White Flint Substation 229, Mandatory Referral, MR2018008

Completed: 7/6/2018

Request to construct an unmanned Pepco substation on vacant property at the intersection of Nebel Street and Marinelli Road;

Figure 2: Proposed Site Plan

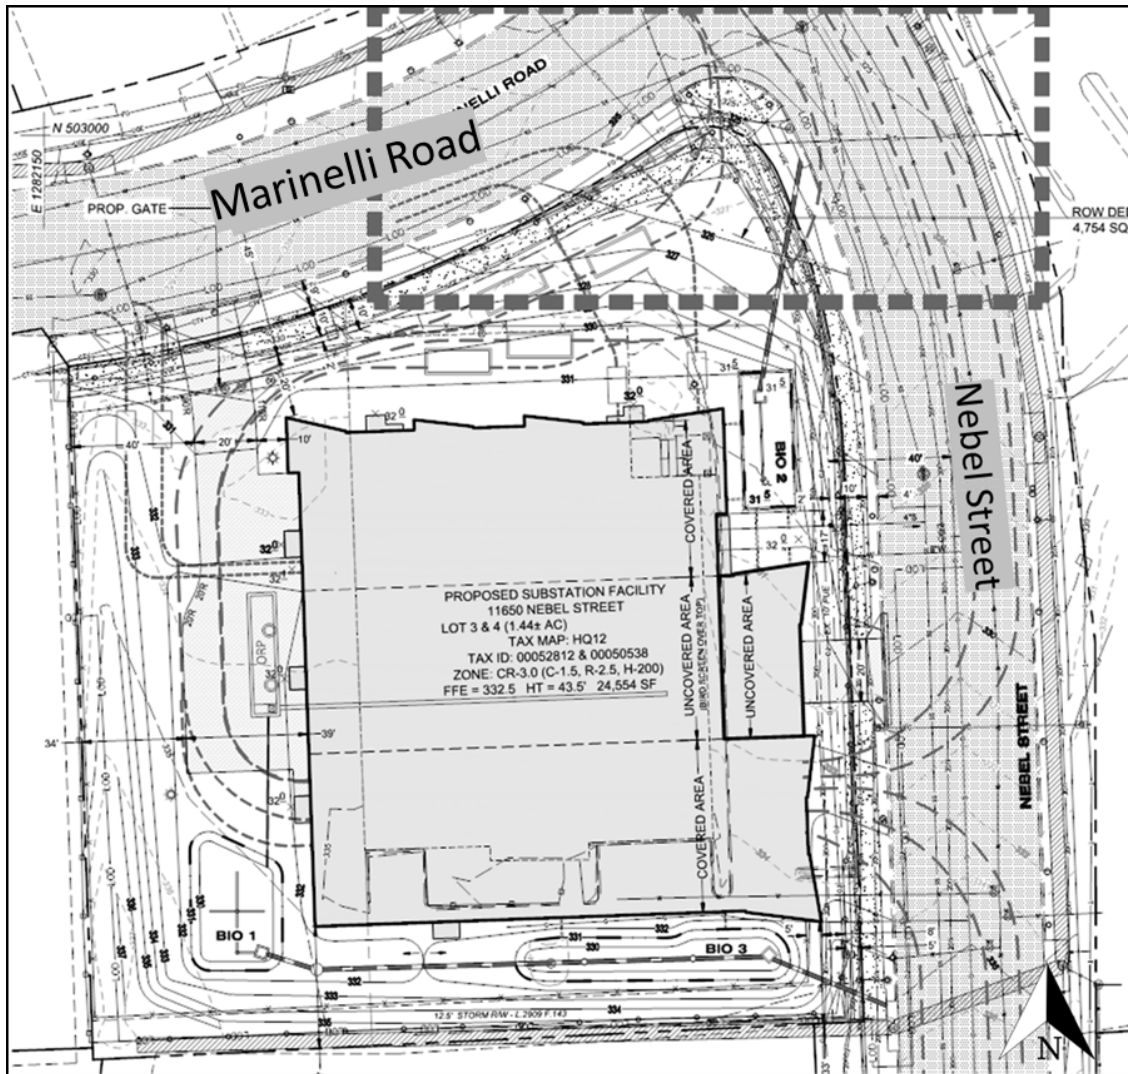
1. Staff recommends further coordination with Staff and the Montgomery County Department of Transportation regarding frontage improvements on Nebel Street and Marinelli Road, including the construction of sidewalks, bike facilities, landscaping and lighting.
2. Continue to work towards approval of Administrative Subdivision Plan No. 620180020. Forest Conservation Law, frontage improvements, and platting requirements of the Property must be met prior to issuance of a building permit.

Architectural Elevations

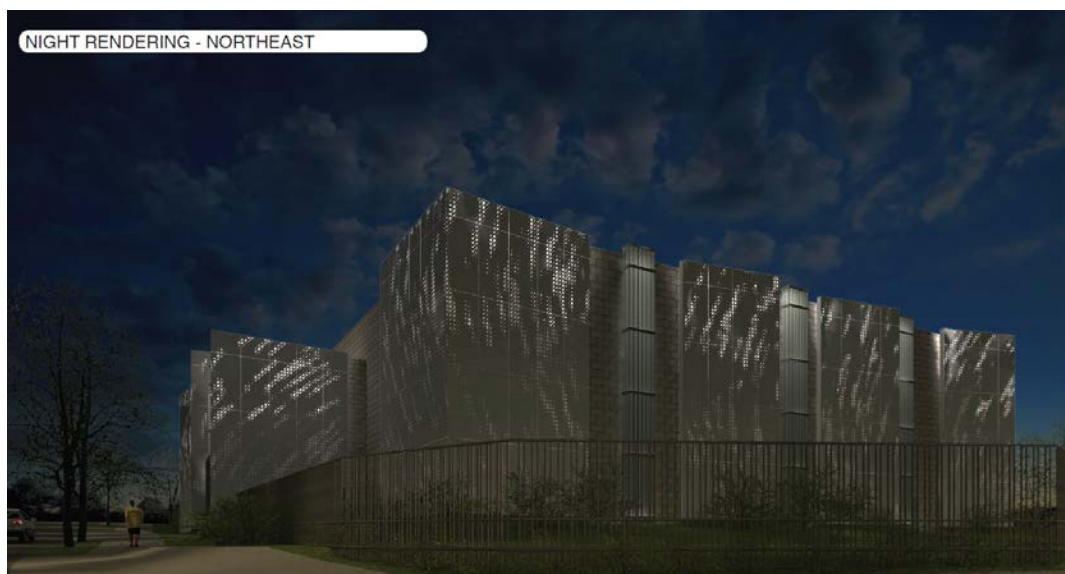
PEPCO proposes a high-quality design for the substation with the use of materials and facade treatment within the architectural elevations. Staff commends PEPCO for designing this substation by adding architectural elements that provide visual interest and better integration with the newer construction of the 2010 *White Flint Sector Plan* area. The breakup of the facade, use of brick, metal screening, and lighting will provide for an interesting and aesthetically pleasing building at the corner of Nebel Street and Marinelli Road.
